Model: Model RN-MF1		Date: 25-May-09	No.: RM016001
Subject: How to access Maintenance Mode		Prepared by: Y.Yoshida	
From: 1st Tech. Support Sec. Service Support Dept.			
Classification:	<input type="checkbox"/> Troubleshooting <input type="checkbox"/> Mechanical <input type="checkbox"/> Paper path <input type="checkbox"/> Product Safety	<input type="checkbox"/> Part information <input type="checkbox"/> Electrical <input type="checkbox"/> Transmit/receive <input type="checkbox"/> Other ()	<input type="checkbox"/> Action required <input checked="" type="checkbox"/> Service manual revision <input type="checkbox"/> Retrofit information <input checked="" type="checkbox"/> Tier 2

Model: RN-MF1		Date: 08-Jan-10	No.: RM016004
Subject: Duplex Jam (Defective Feeler)		Prepared by: Y. Gaman	
From: 2nd Overseas Tech Support Sec. 2nd PQM Dept			
Classification:	<input checked="" type="checkbox"/> Troubleshooting <input type="checkbox"/> Mechanical <input checked="" type="checkbox"/> Paper path <input type="checkbox"/> Product Safety	<input type="checkbox"/> Part information <input type="checkbox"/> Electrical <input type="checkbox"/> Transmit/receive <input type="checkbox"/> Other ()	<input typ

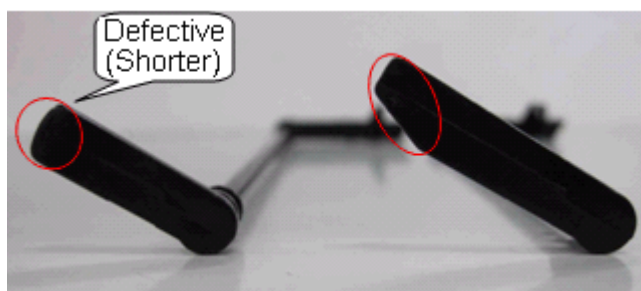
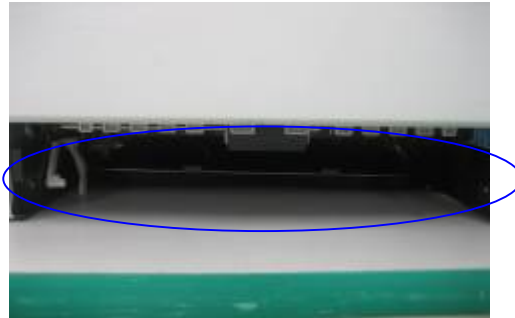
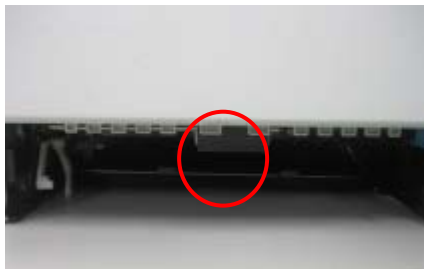
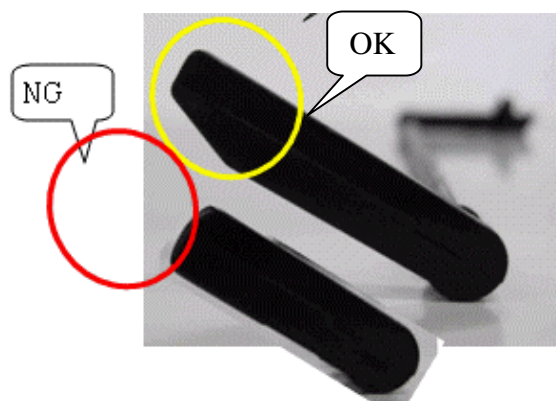
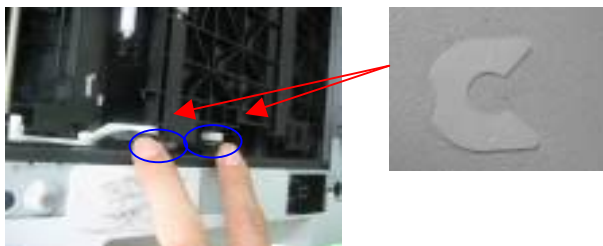
A jam may occur during duplex printing.

A defective feeler in the duplex unit (Horizontal Paper Feed) may cause a detection failure.

Defective feeler: M0134778 (Feeler:Sensor:Horizontal Transport)

The defective feeler is shorter than a normal feeler. This is not a design problem.

Check the feeler (M0134778) and if it is defective, replace it. Refer to the procedure.

- 3) Check the shape of the feeler: M0134778
(Feeler:Sensor:Horizontal Transport).

Check the shape of the feeler in the middle of the lower guide with a flashlight.

The defective feeler is shorter.

Replace the feeler if it is defective.
Remove the AIO first before you do this procedure.

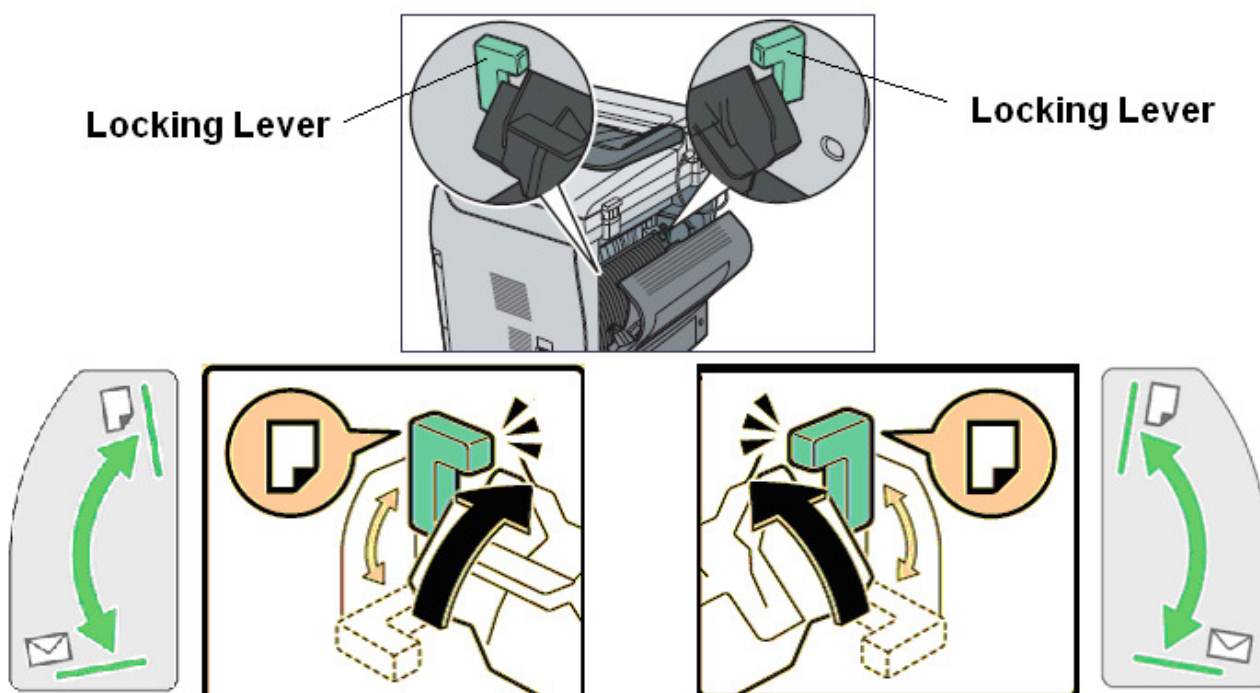
Some areas of the image are missing when printing onto plain paper.

The locking levers are not in the raised position when printing begins.

Note: Toner may not fuse properly to the paper when printing onto plain paper with the locking levers in the lowered position.

- If this symptom occurs, raise both locking levers and try printing again.
- As mentioned in the CAUTION sheet, raise both locking levers when setting up this machine. This is because the levers should always be in the raised position when printing onto regular paper.

Important: When printing onto envelopes, lower the levers. Then, after the job is completed, return the levers to the raised position.

PSU (pg. 80)

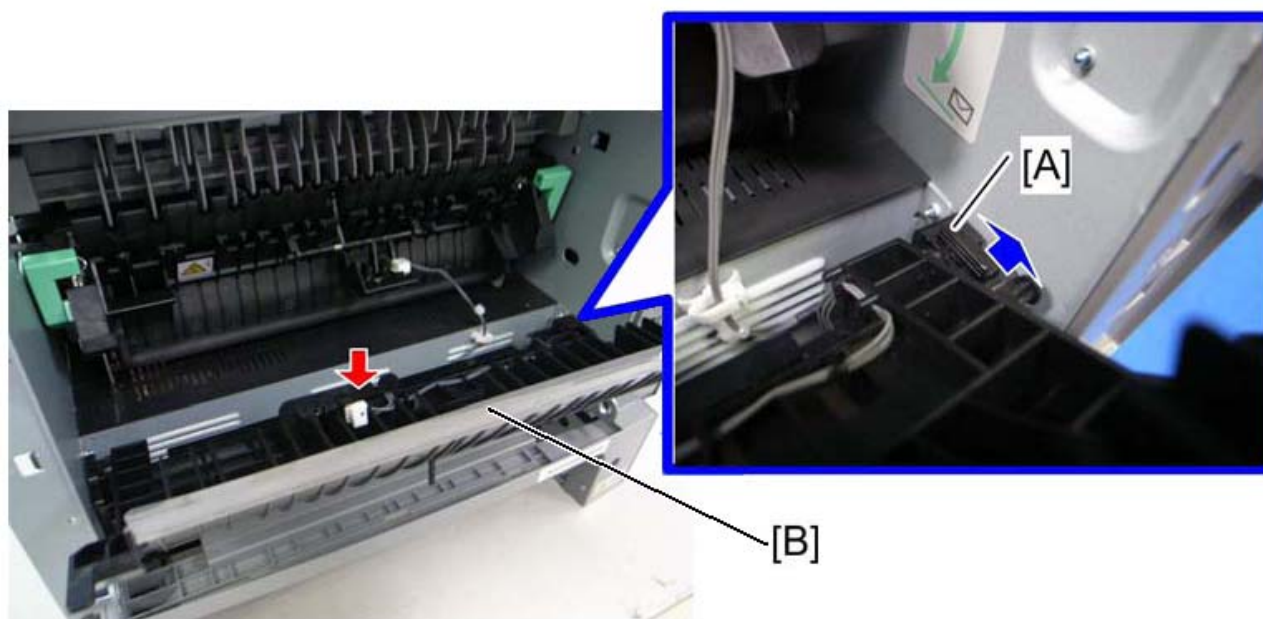
Replace Step 17 of the PSU replacement procedure with the following.

17. Release the lock [A], and then remove the entrance guide [B] (Connector x 1).

U008 MAIN FRAME/PAPER FEED

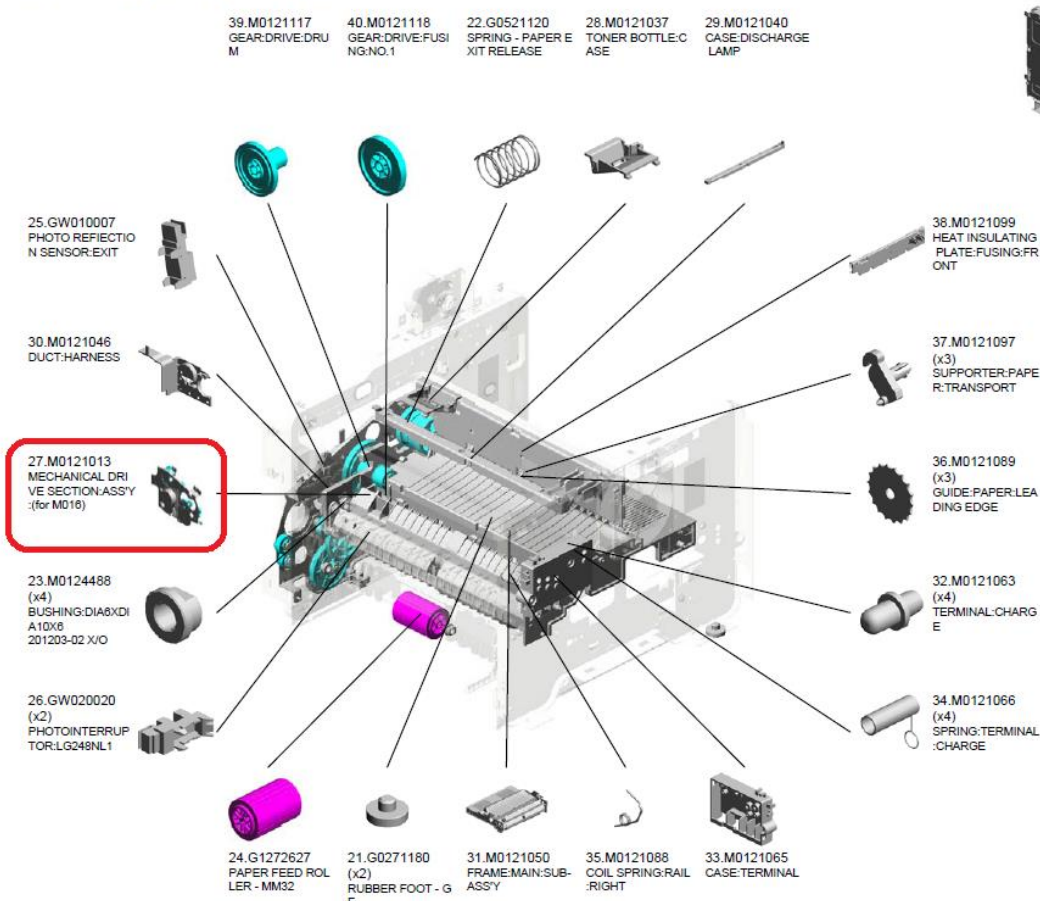
Parts Catalog correction (M016):

Description	PN	Correction	Reason
MECHANICAL DRIVE SECTION:ASS'Y:(for M016)	M0121013	Part Elimination	This part cannot be provided by the manufacturer. Please order the sub pieces instead of the ASS'Y.

U014
ELECTRICAL

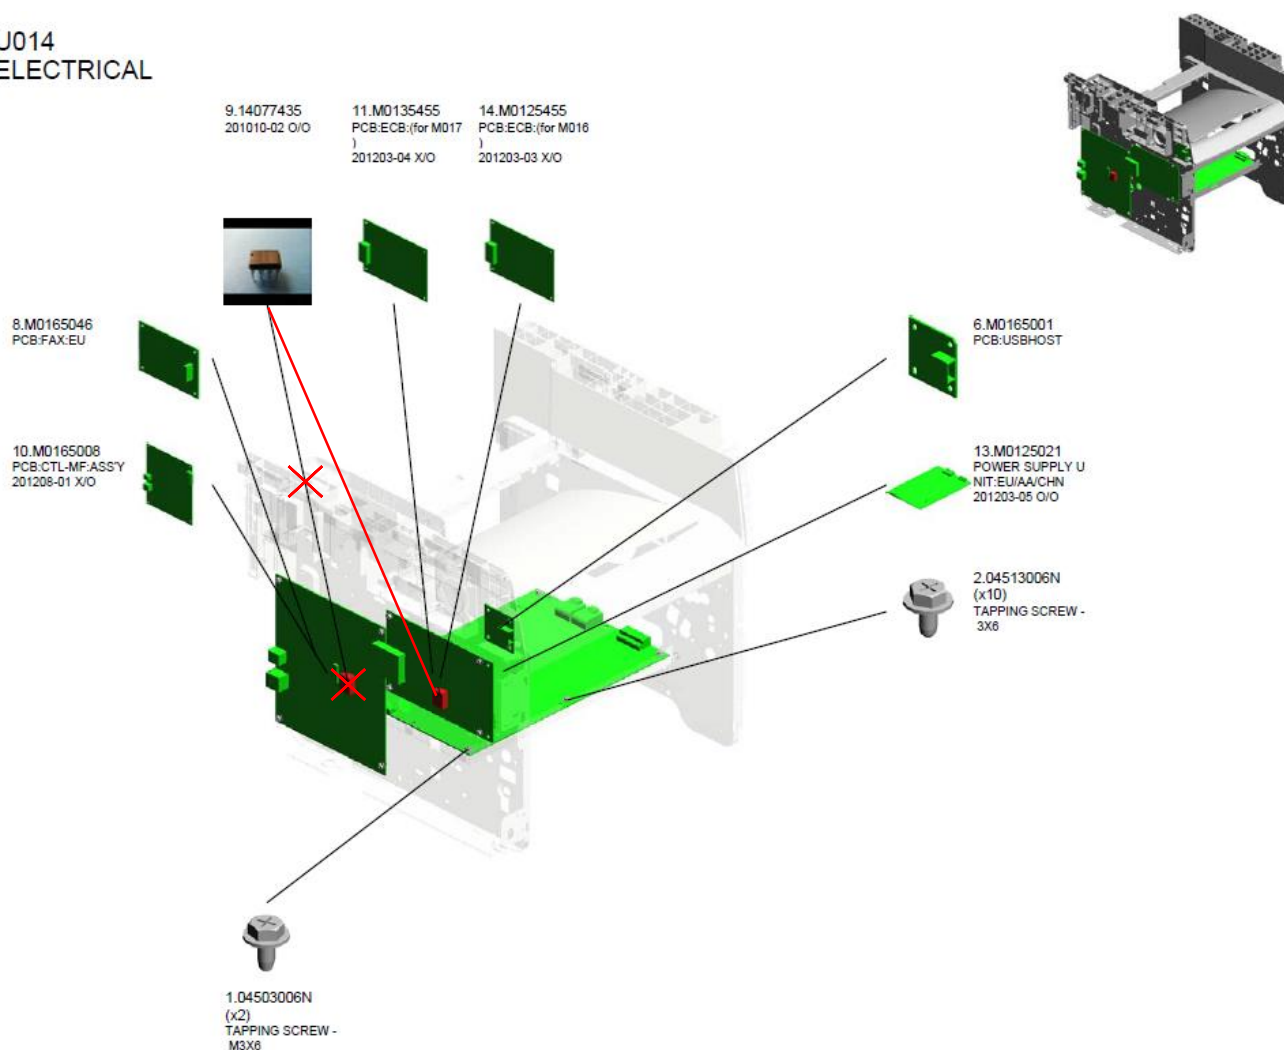
**The only NVRAM for RN-P1/MF1 is
EEPROM:CAT93C76LI-G(14077435) on Engine
PCB.**

***14076657 is not available for RN-P1/MF1.**
